Our Ref: K-2578-IRR-001
Your Ref: OP3043/2019
Date: 31 May 2019

Re: Information Request – Operational Works – 12 Crawford Street, Mossman

Response

JOB No: **K-2578**
 SHEET: **C10 | E**
 SCALE: 1:1000H 1:100V (@ A1)

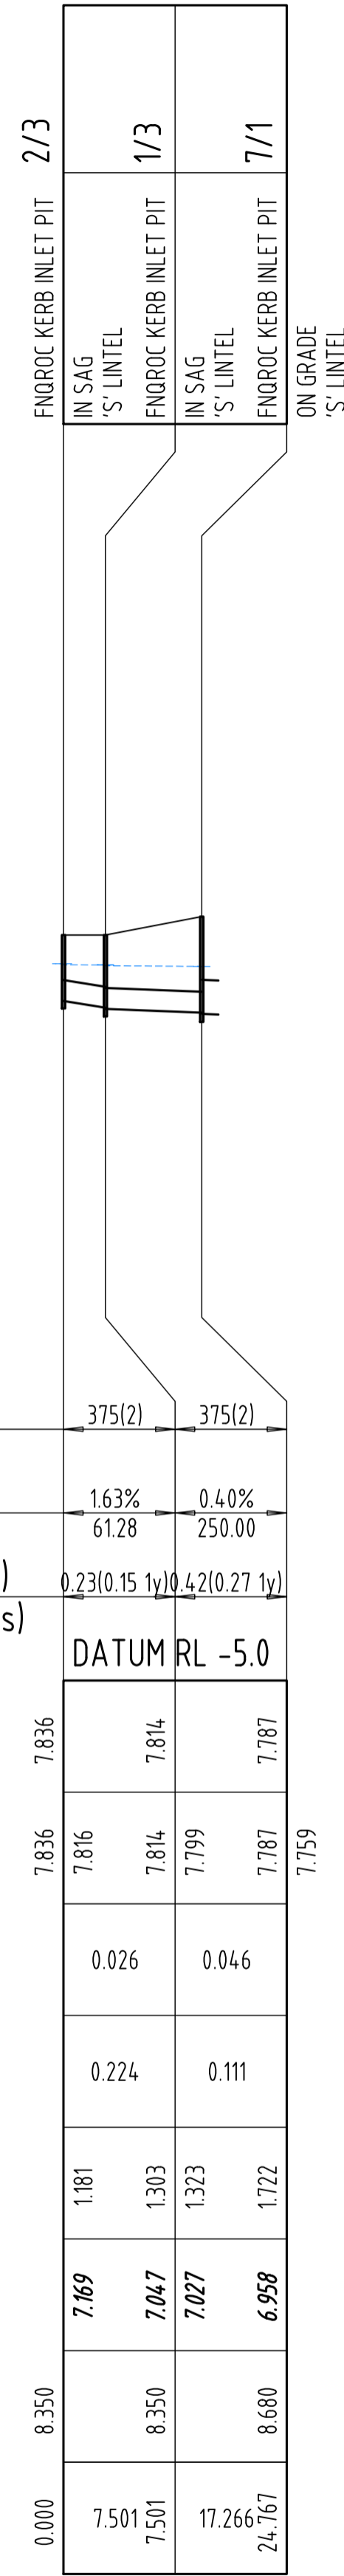
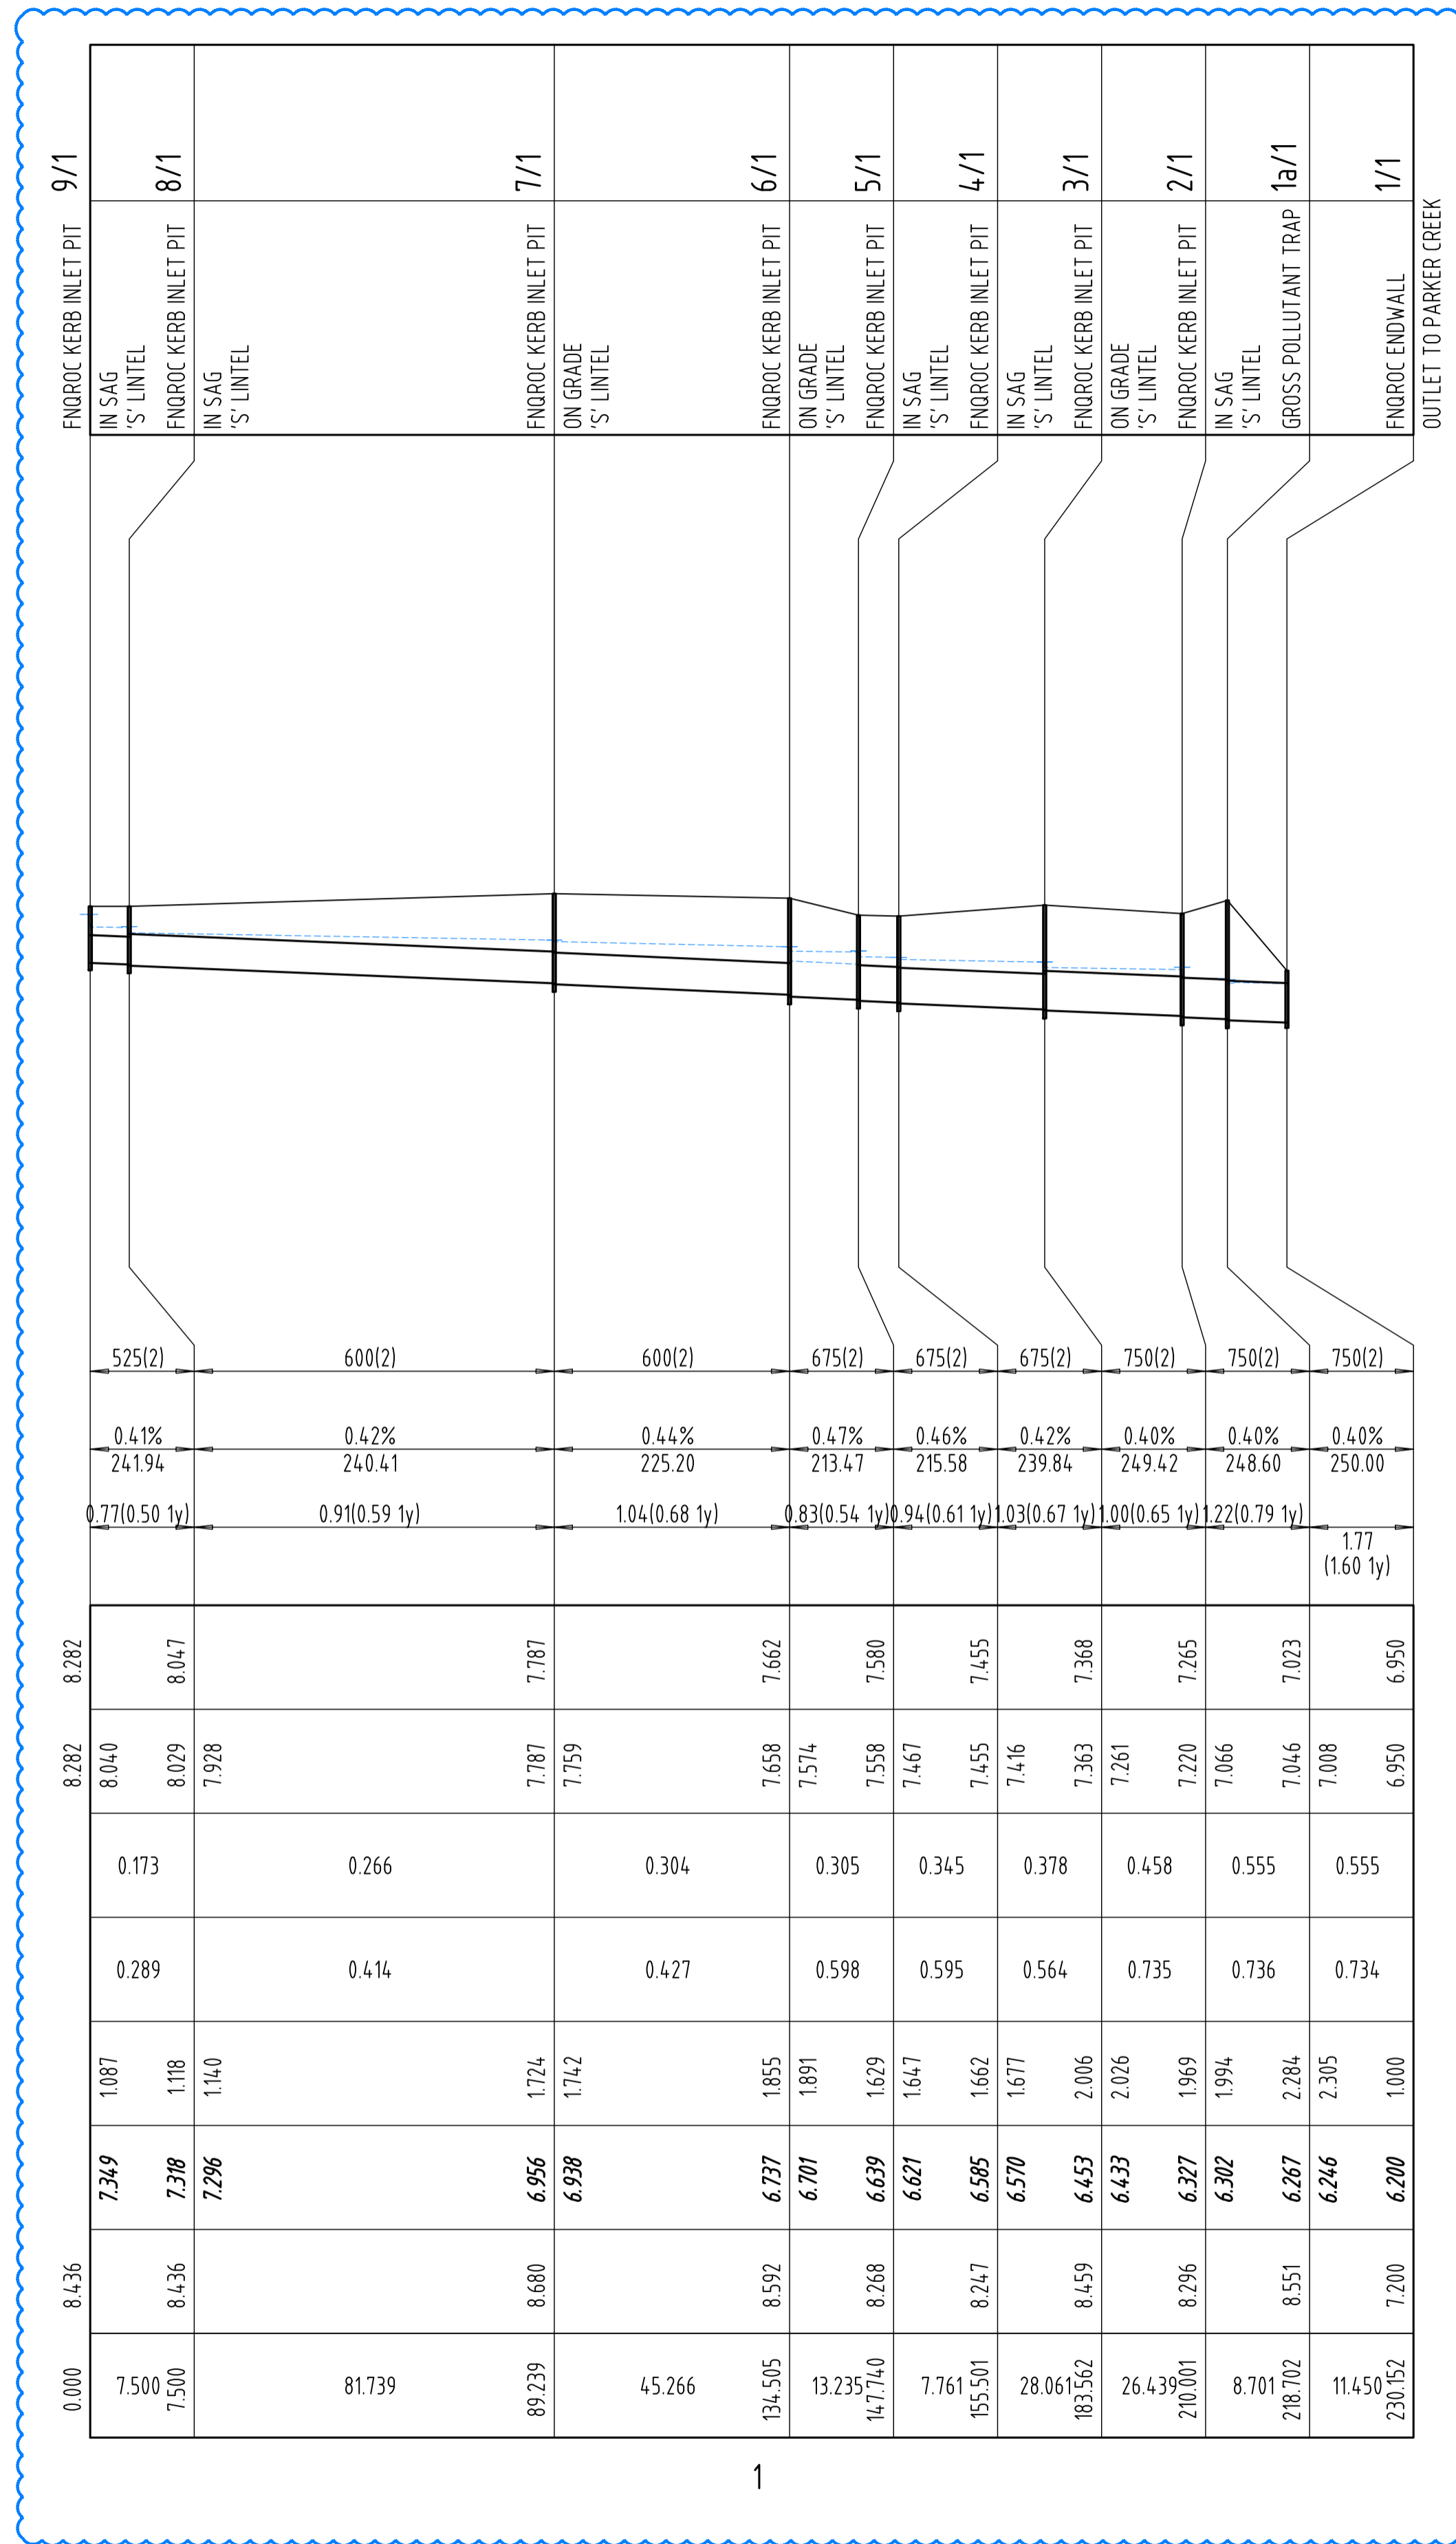
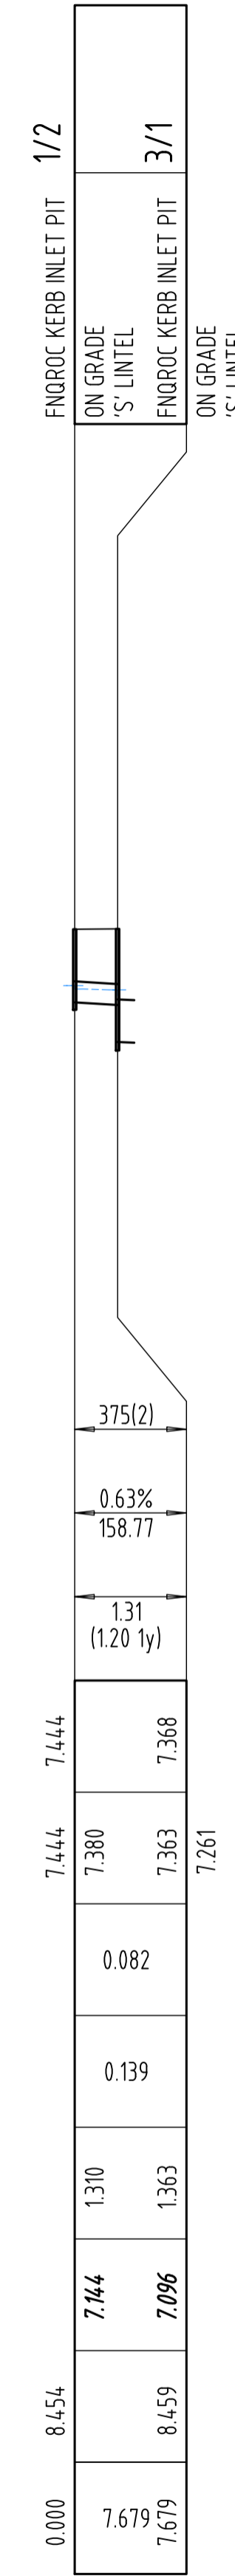
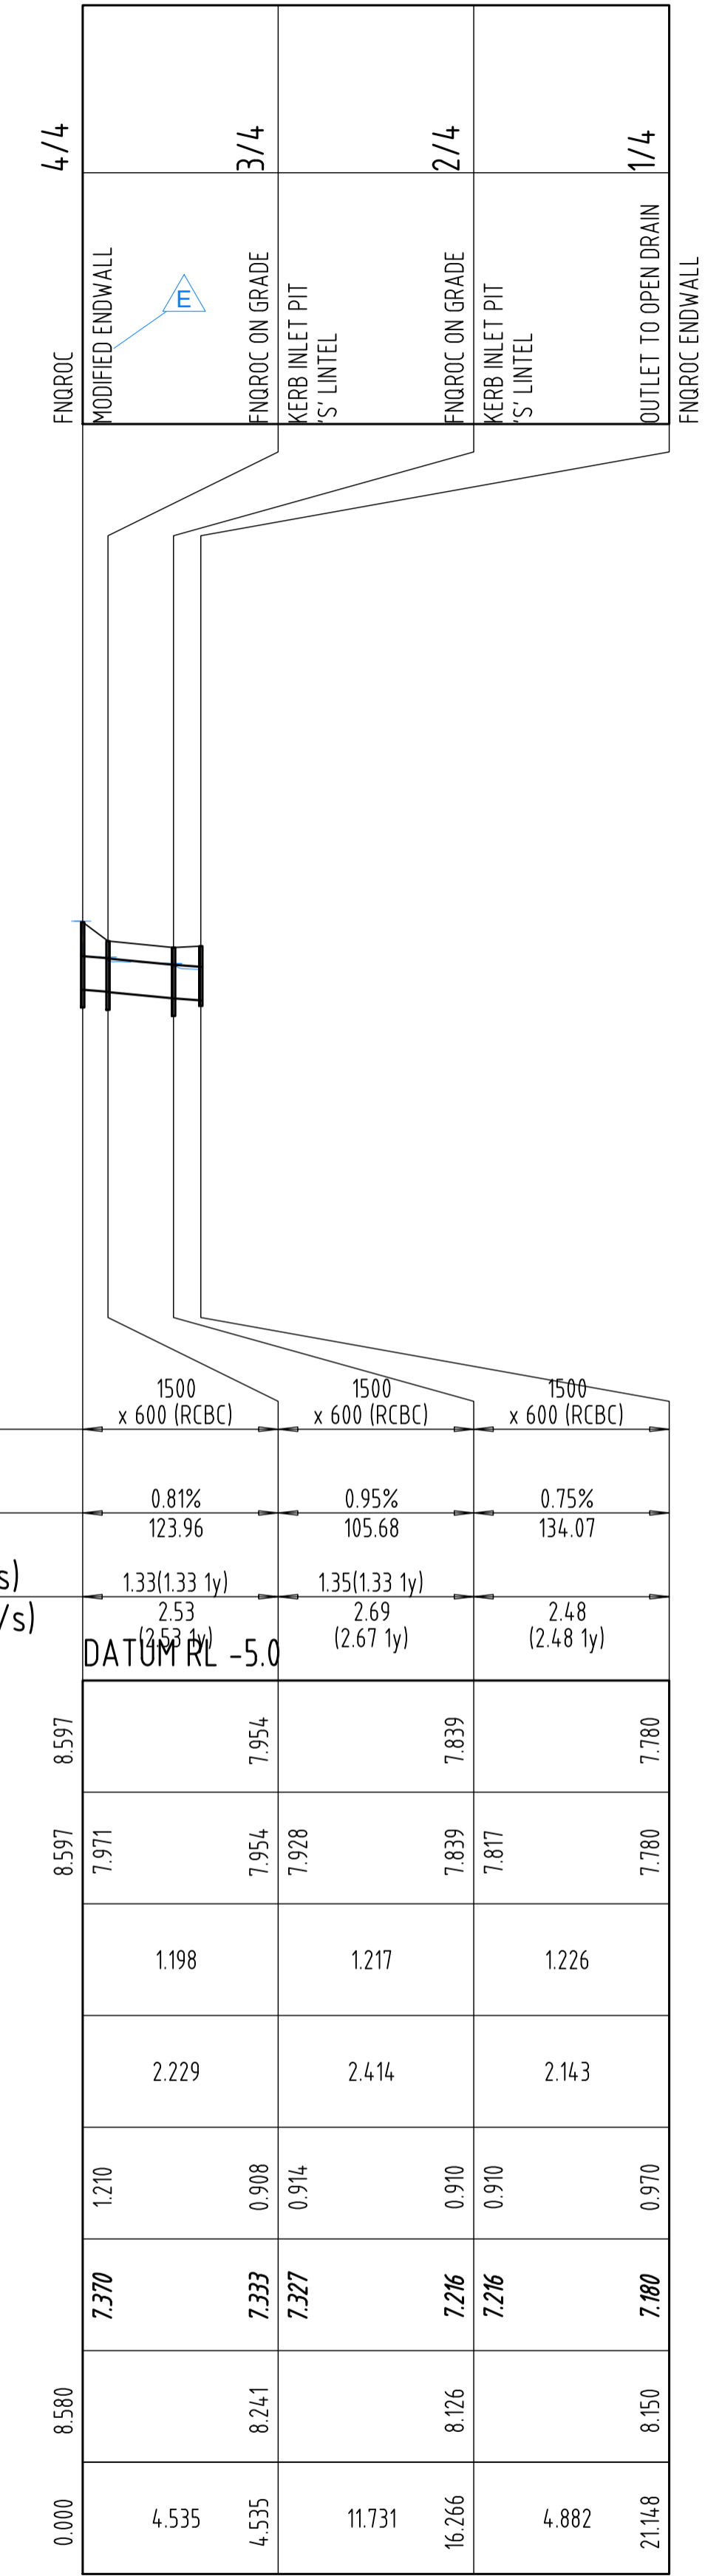
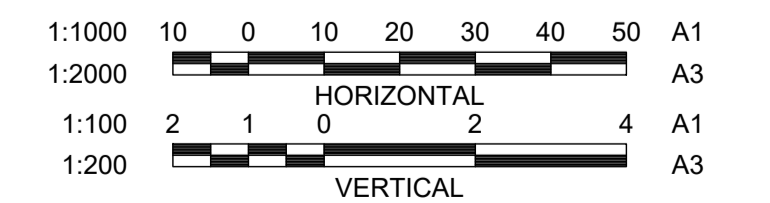
- 6. The longitudinal calculation section indicates that for the 5 yr ARI event, the water surface elevation at headwall 4/4 will be 8.597m. The Road and Drainage plan (C03) lists the existing lot level on the south east corner of 5 – 7 Crawford Street as 8.586m. The design inundates the existing property in a 5 year ARI design flow.**

Based on the information before Council, Officers have concerns that the proposed culvert arrangement will result in an adverse impact to 7 Crawford Street. Please provide advice confirming that the proposed arrangement, will not result in an impact to 7 Crawford Street. In addition confirm that the QUDM minimum freeboard is achieved for Lot 7. Submit a revised plan if any changes to the culvert arrangement are required.

The longitudinal calculation on drawing K-2578 Sheet C10 for culvert 4/4 – ¼ clearly indicates that it is for the 10 yr ARI event not the 5 yr ARI event as recorded by the reviewer.

The proposed Q10 culvert will not have a worsening impact on No 7 because it will convey all stormwater flows up to the Q10 event under Crawford Street (currently Q10 flows overtop the road with the existing 750 dia culvert having only Q2 capacity). The road low point of 8.43 does not change and the proposed Q10 culvert has a beneficial effect providing No 7 Crawford Street with a freeboard of at least 300mm.
